ADDENDUM NO. 4

Perry Meridian High School Phase 1 – Student Activity Center
401 W. Meridian School Road
Indianapolis, IN 46217

PROJECT: PERRY MERIDIAN HS PHASE 1
PROJECT NUMBER: 24173P
DATE OF ADDENDUM: April 16, 2026

RE: Addendum 04

C-8.7

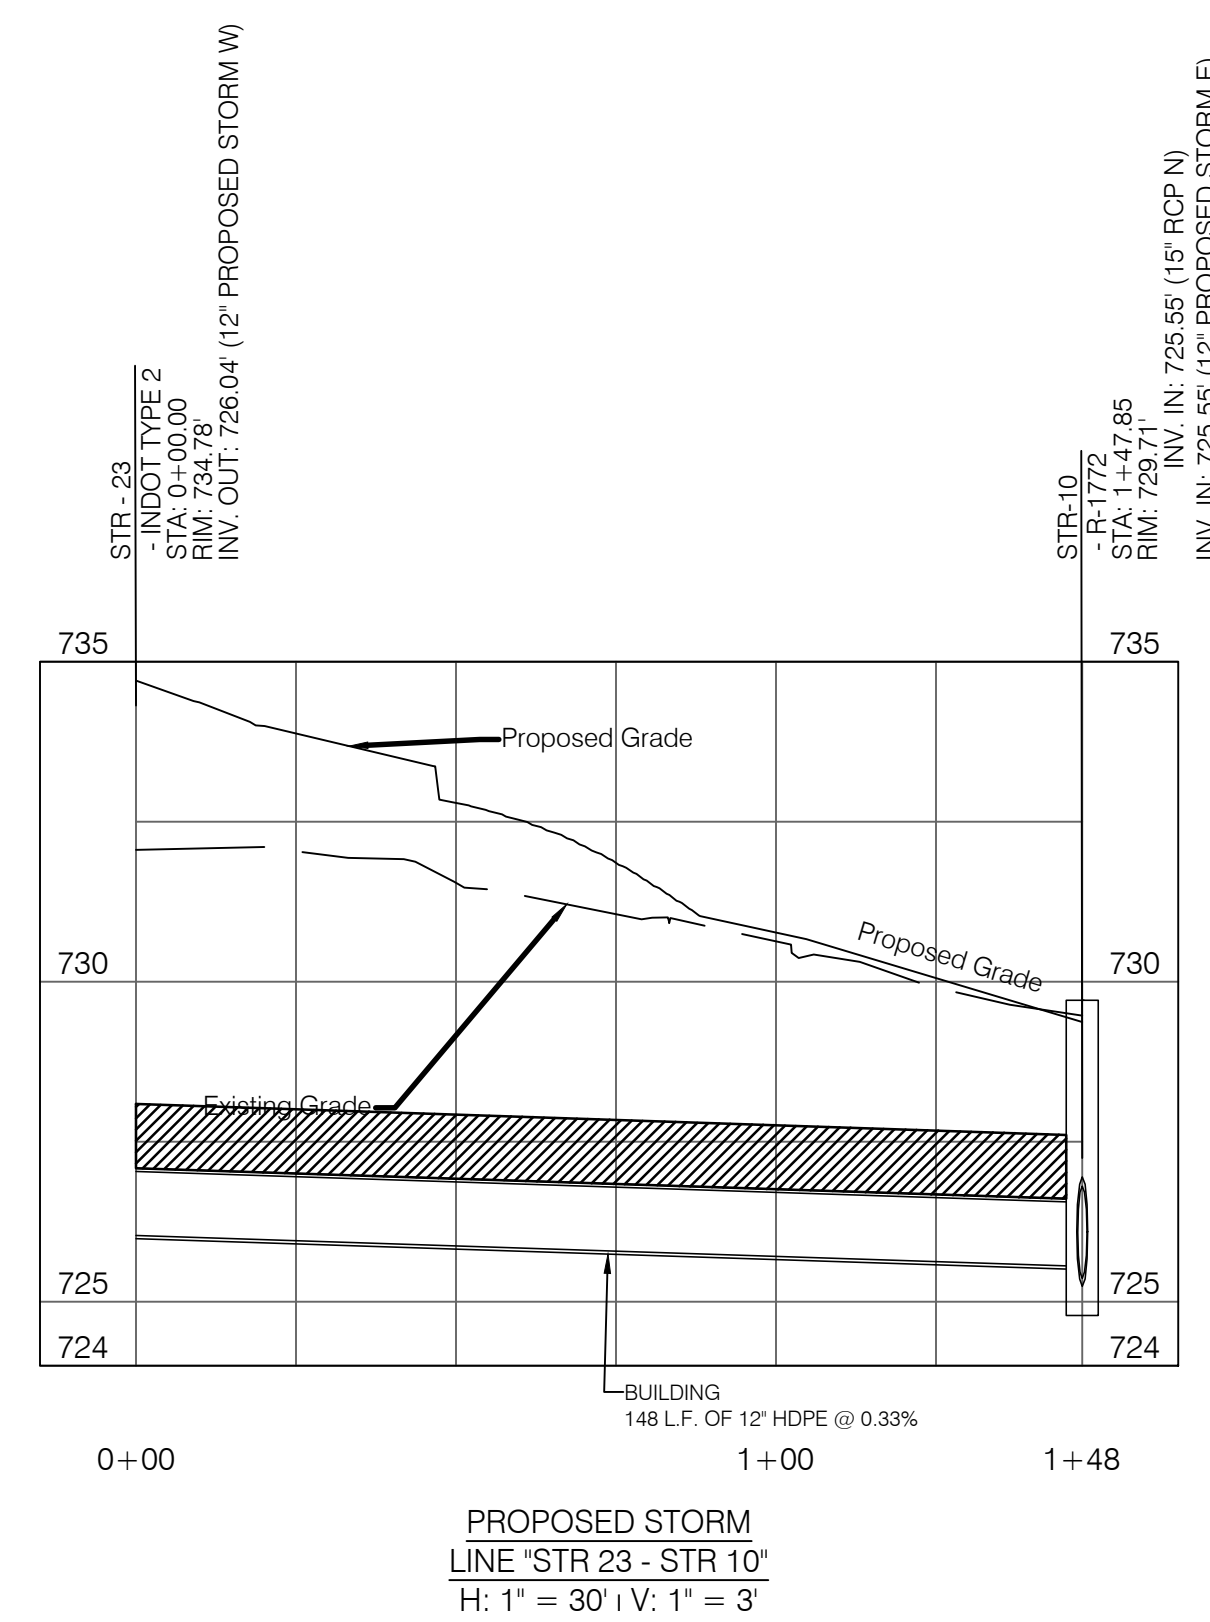
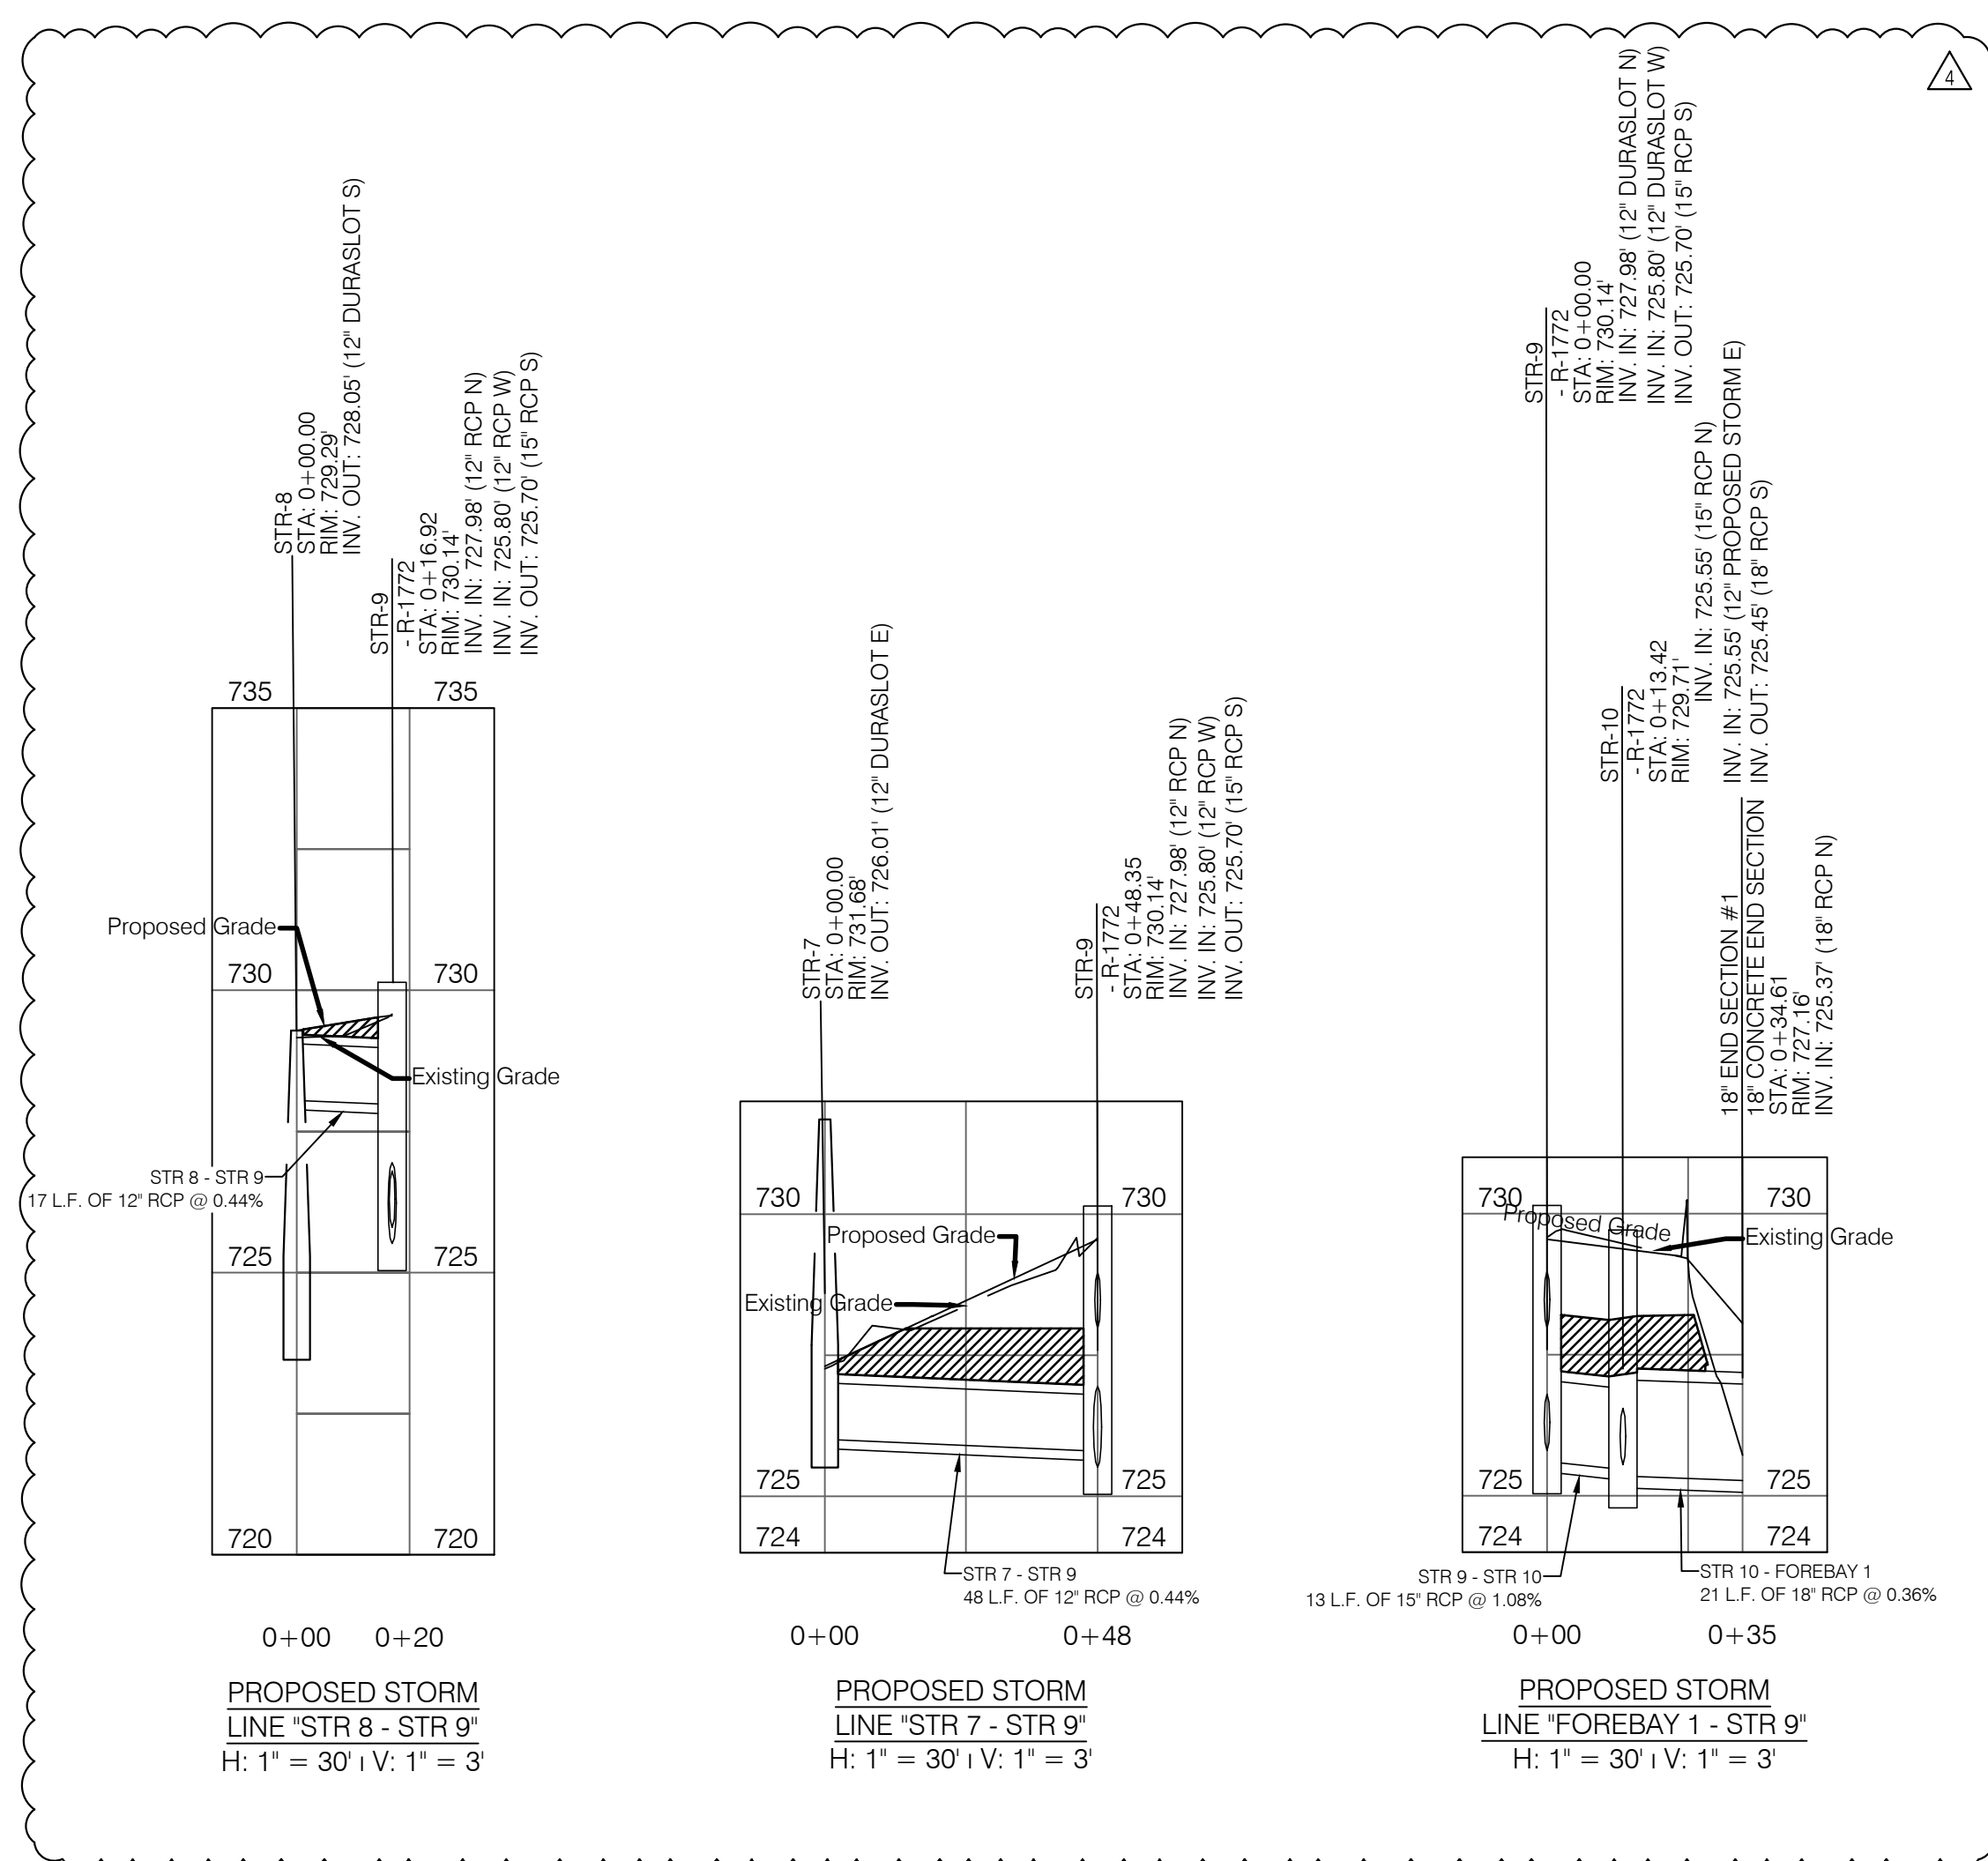
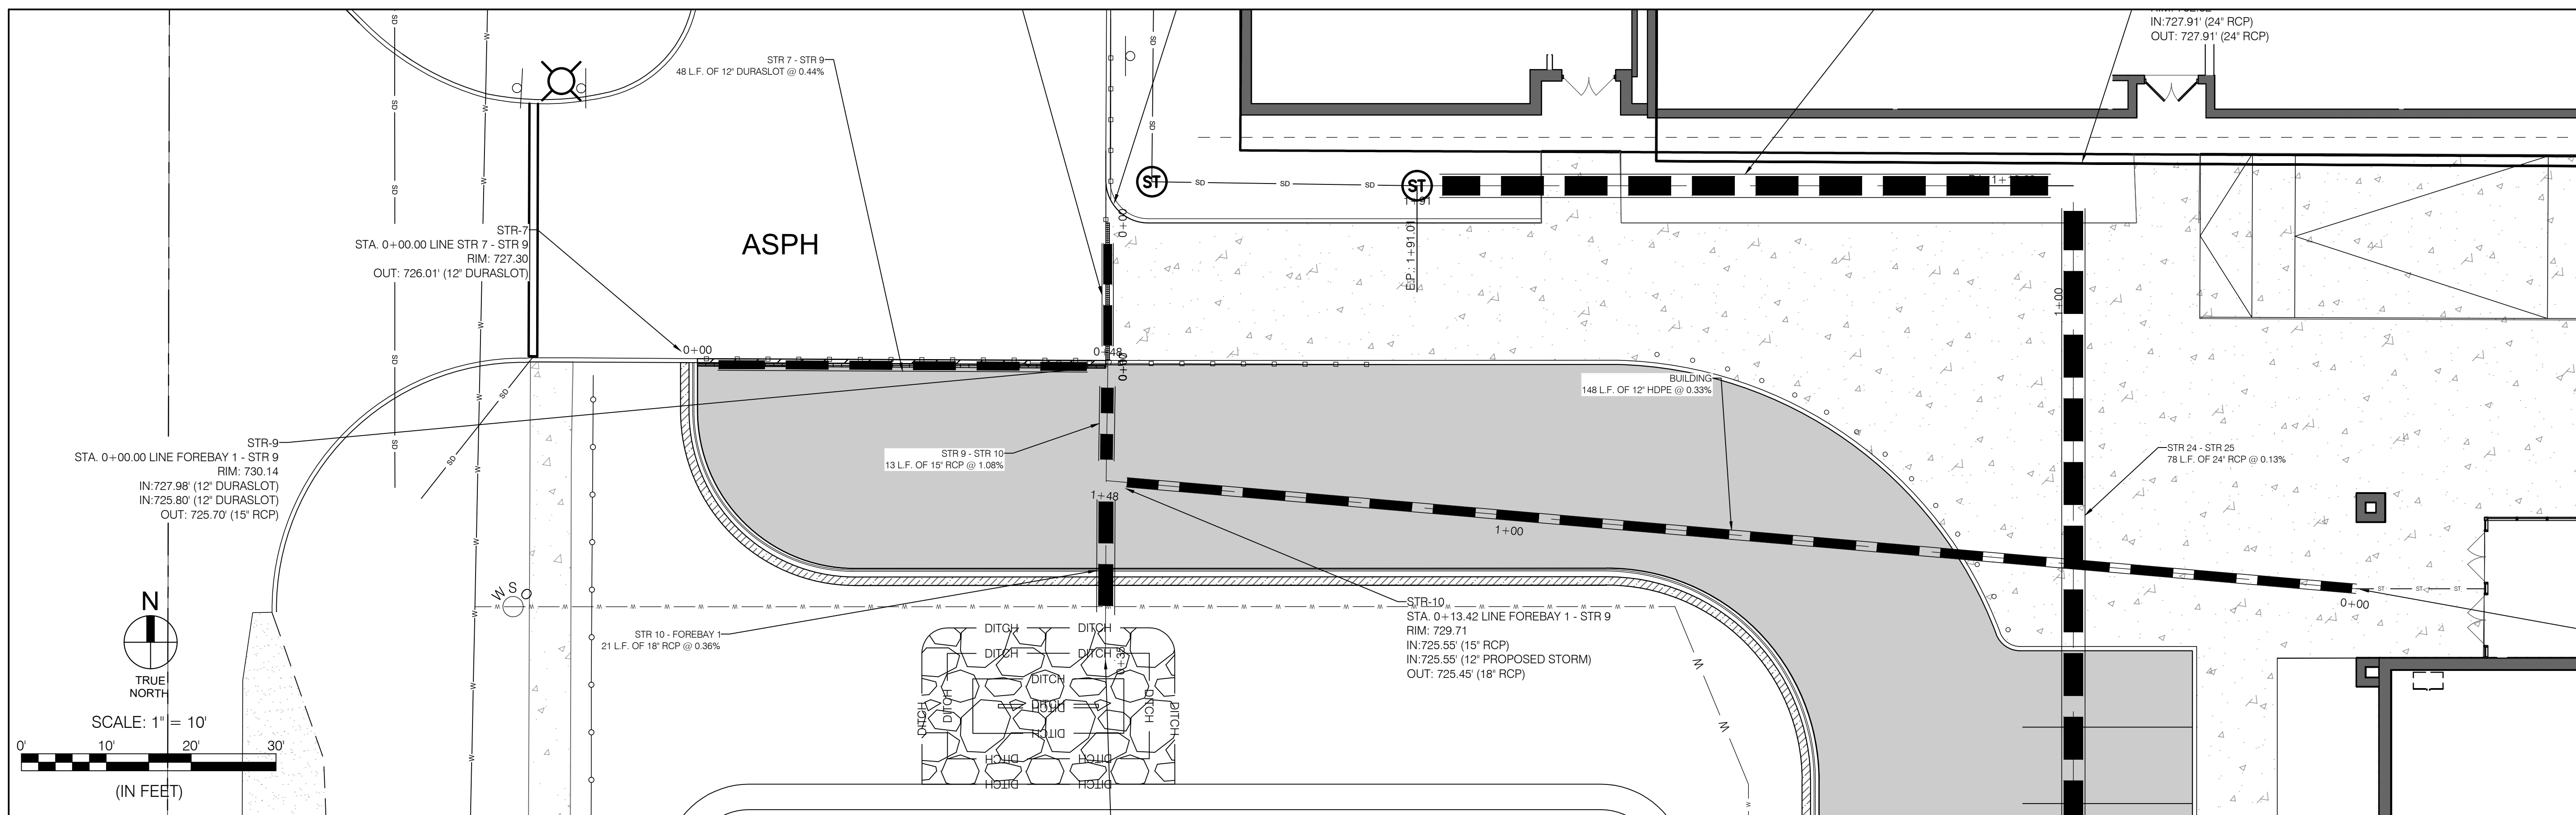
a. Side panels – SPN-44-36
b. Plexi Front Door Vented – PVFD-44
8. **Q:** 12" Storm Runs Between Structures 7, 8, & 9 – are these 12" RCP or 12" Duraslot? Profiles show RCP but Data table shows duraslot.
A: See attached JQOL Addendum 04.

Sheet C-8.7

- Storm profiles for STR. 7, 8, and 9 were adjusted to show the pipe material change from RCP to Duraslot.
